**RE: Submittal of Non-Significant Revision #13 to Permit to Mine
Lost Creek Project PT788**

Enclosed with this cover letter is Non-Significant Revision (NSR) #13 to the Permit to Mine for the Lost Creek ISR Project PT788 as detailed on the index sheet. The primary purpose of the revision is to add language for the approved Class V injection wells.

INDEX SHEET FOR MINE PERMIT AMENDMENTS OR REVISIONS

MINE COMPANY NAME: Lost Creek ISR, LLC MINE NAME: Lost Creek PERMIT NO.: PT0788

FIGURE OP-5a
Project Water Balance
Production Only
Lost Creek Permit Area

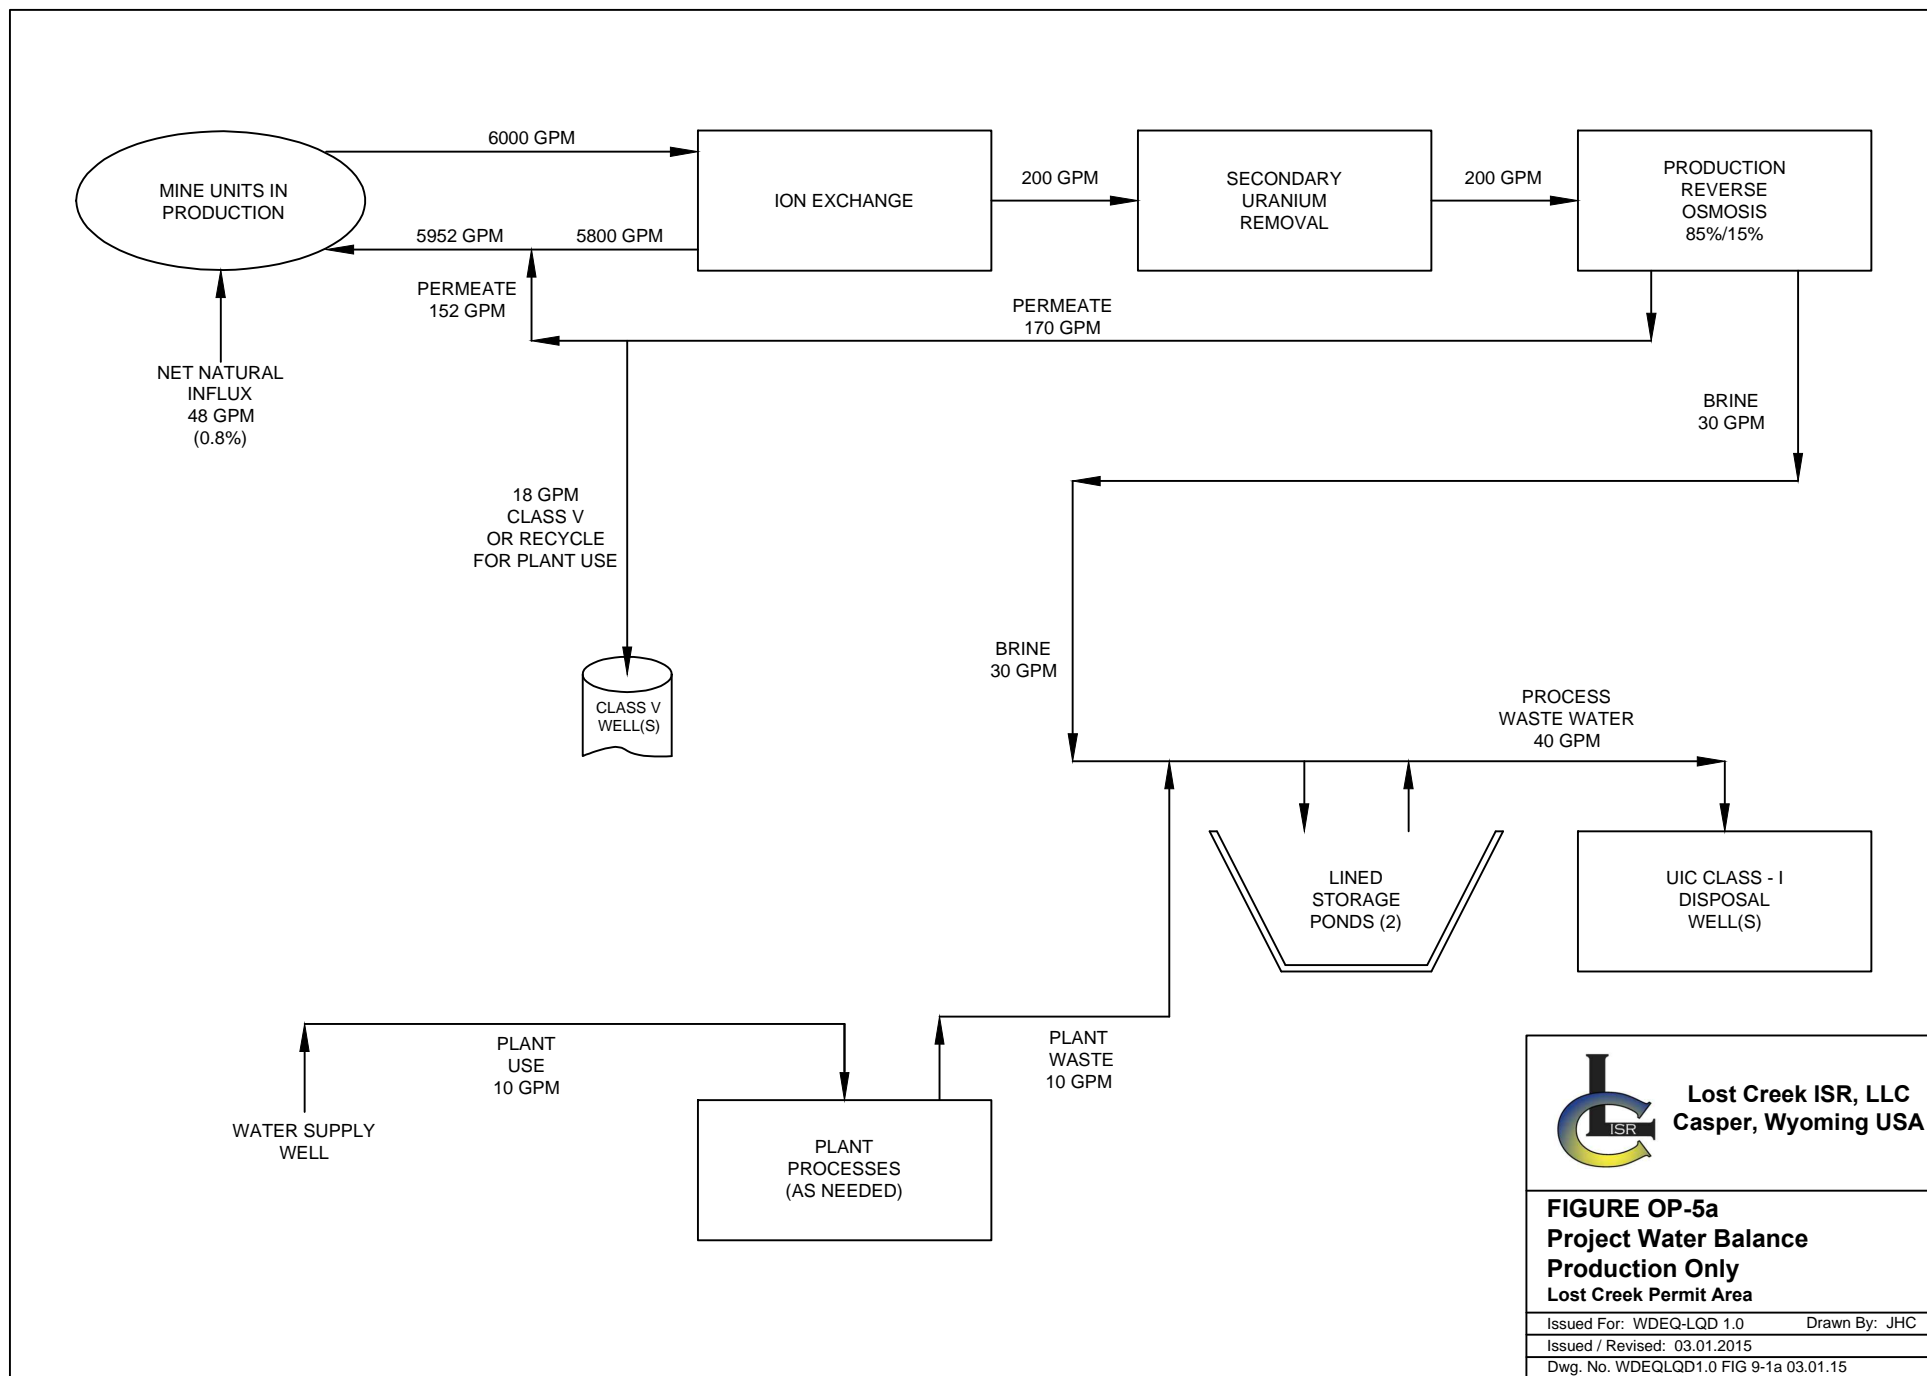
Permit to Mine – Table of Contents	Table of Contents – Detailed, Page xi (Rev Nov11)	Table of Contents – Detailed, Page xi (Rev2 Apr16)	Added line “OP 5.2.3.2 UIC Class V Wells”
Permit to Mine Volume 5 - Operations Plan	Page OP-ii (Rev10 Nov10)	Page OP-ii (Rev11 Apr16)	Added line “OP 5.2.3.2 UIC Class V Wells”
Permit to Mine Volume 5 - Operations Plan	Page OP-1 (Rev6 Feb10)	Page OP-1, 77-79 (Rev7 Apr16)	Added language for Class V wells.
Permit to Mine Volume 5 - Operations Plan	Page OP-54 (Rev9 Sep10)	Page OP-54 (Rev10 Apr16)	Added language for Class V wells. Edited Class I well language.
Permit to Mine Volume 5 - Operations Plan	Page OP-77 - 79 (Rev7 Feb10)	Page OP-1, 77-79 (Rev8 Apr16)	Added language for Class V wells.
Permit to Mine Volume 5 - Operations Plan	Page OP-80 (Rev9 Sep10)	Page OP-80 (Rev10 Apr16)	Added language for Class V wells. Edited Class I well language.
Permit to Mine Volume 5 – Operations Plan	Figure OP-5a – 5f (Oct09)	Figure OP-5a – 5f (Mar15)	Added Class V disposal option graphic
